Hailey Planning and Zoning Commission

Monday, August 19, 2024

STAFF REPORT
Hailey Planning and Zoning Commission
Regular Meeting of August 19 2024

To: Hailey Planning and Zoning Commission
From: Ashley Dyer, Community Development Planner

Option B:

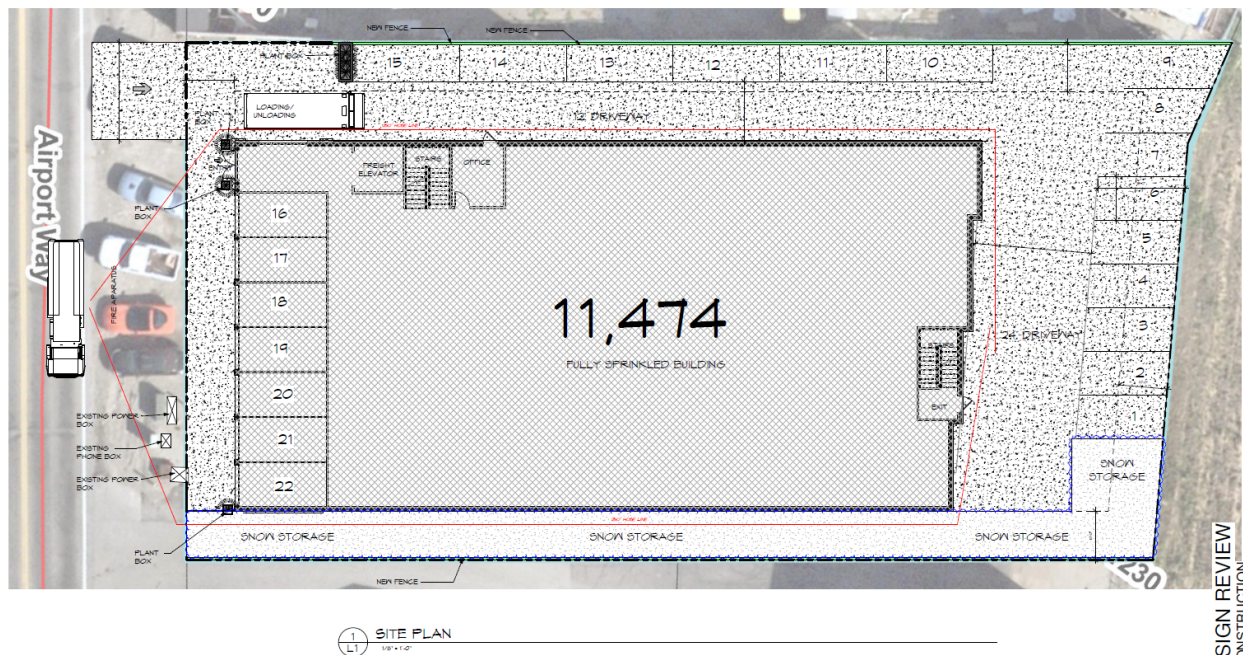
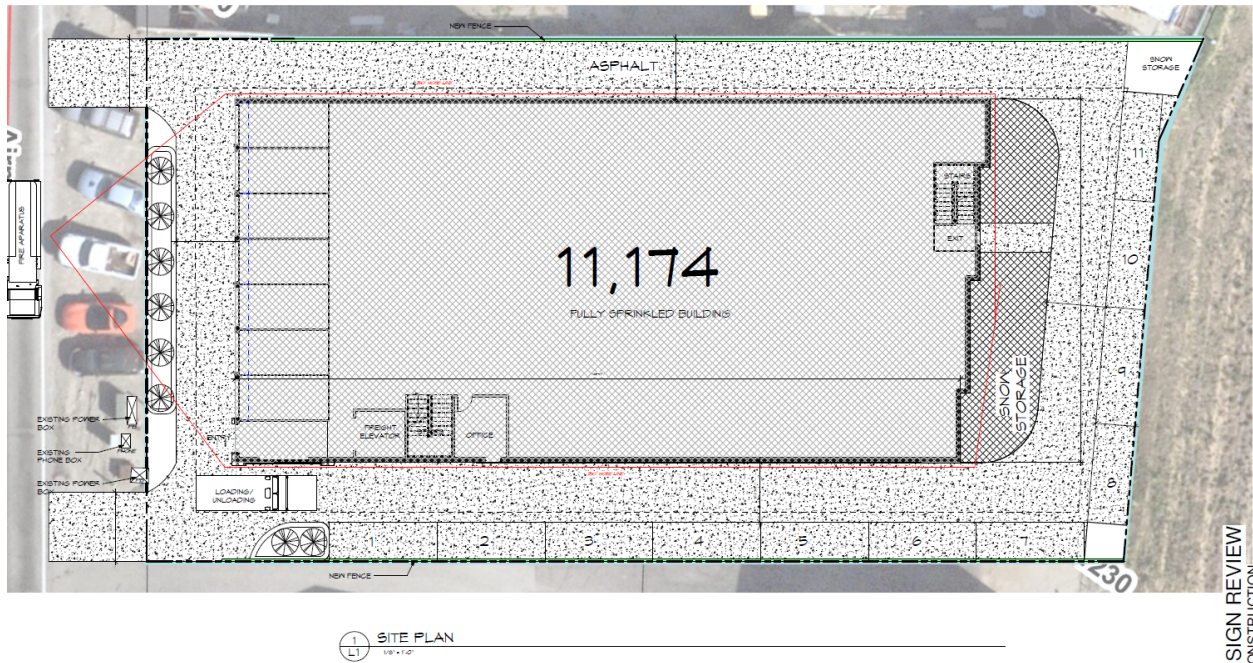
As shown above, Option A does not offer year-round vehicular access around the proposed building, as the area to the south of the building will be used for the entirety of the site’s required onsite snow storage. However, the onsite parking requirement for the proposed commercial building (22,152 square feet of industrial storage space, 22 parking spaces therefore required) is fully met with the proposed Option A site place. Other key distinguishing features of Option A include a more limited scope of landscaping (as compared to Option B), a single primary curb cut at the northwest corner of the site for Airport Way ingress/egress, and the freight elevator, stairs, and office located on the north side of the building.

Building Option B offers a site plan with full, year-round site circulation, including two (2) curb cuts in both the northwest and southwest corners of the property. However, on-site parking requirements (21,571 square feet of commercial building area, requiring a minimum of 21 on-site parking spots) are not met with this building design proposal. Only eleven (11) on-site parking spots are shown. Snow storage requirements are also not met with this design, which will likely require the Applicant to haul a large portion of their snow off-site during moderate to heavy snow events. The freight elevator, stairs, and office areas are also mirrored to the southern side of the building in this Option B design, as compared to Option A. A more substantial landscaping buffer between Airport Way and the building frontage is also shown with Option B. The Applicant may wish to discuss their intentions for submitting a building design for consideration that does not meet onsite parking requirements, and if there may be an opportunity to augment Option B designs to include all presented features and minimum parking requirements.

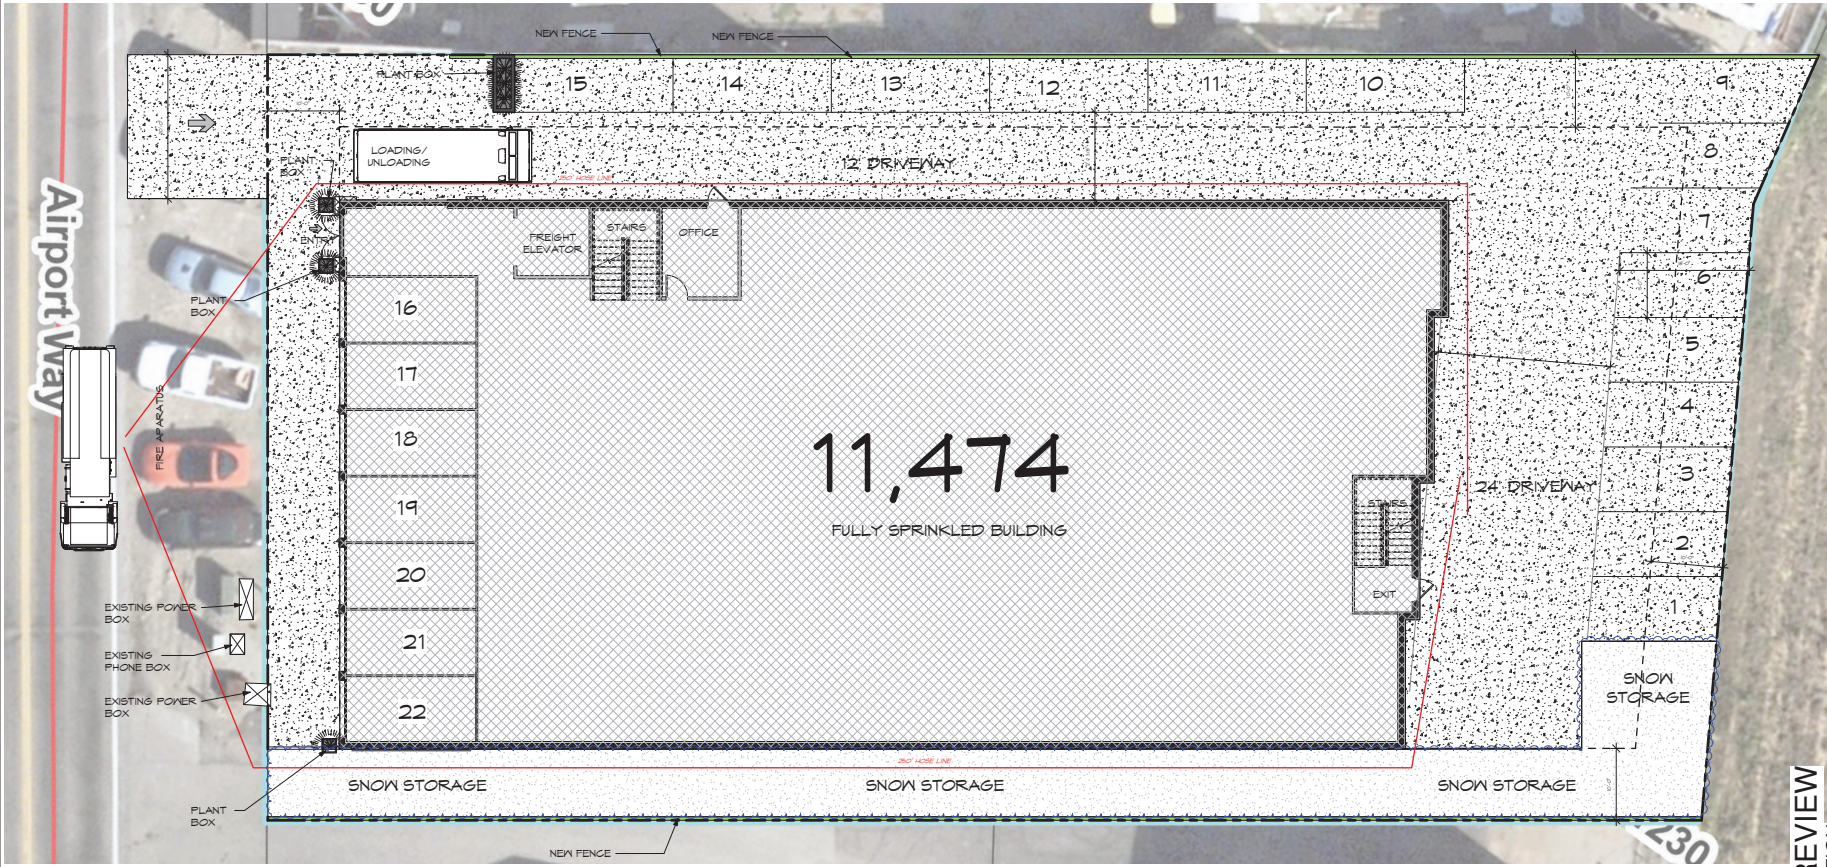
- 5. Landscaping/Useable Open/Park Space.** Option A shows very little landscaping on-site, limited to four (4) planter boxes along the building's western, street-facing façade. Option B presents six (6) tree plantings between the building frontage and the right-of-way parking area along Airport Way, along with two (2) additional plantings on the building's southern elevation. Staff prefer the overall design and intent of Option B landscaping, which utilizes natural features to buffer the highly industrial proposed building with the busy and highly industrial Airport Way. Both Option A and Option B comply with the Hailey Municipal Code's landscaping requirements for non-residential buildings in the Light Industrial (LI) Zoning District. See below:

However, Staff would like to see the Applicant prioritize landscaping and natural elements across their project in any future full Design Review submittals, to the greatest degree possible. Possible features for future inclusion could include things like river rock and drought-tolerant planting strips around the building perimeter, or "living walls"/climbing plants on building facades. Any project additions that offer ecosystem benefits like improved air quality, pollinator habitat, and/or cooling effects are always supported by Staff in the Light Industrial (LI) Zoning District.
